# TCG 01-G & TCG 02-G Firmware Release Notes

VERSION F2.28r3 (November 2017)

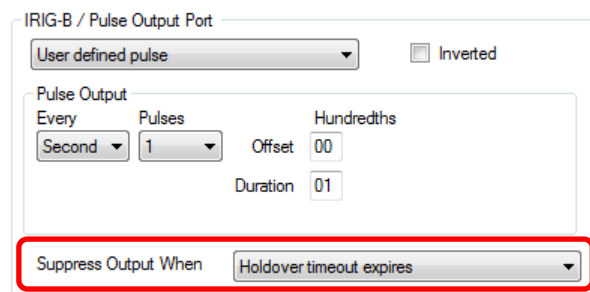
Added the ability to independently suppress individual outputs based on inaccuracy threshold or holdover timeout. When “holdover timeout expires” is selected, that particular output will stop providing a time signal when the clock is out of sync and the specified holdover time has expired.

When “Inaccuracy threshold is exceeded” is selected, that particular output will stop providing a time signal when the clock is out of sync and the reported inaccuracy has exceeded the specified maximum inaccuracy. When “Never” is selected, that particular output will continue to provide a time signal even when the clock is out of sync.

This applies to the following ports:
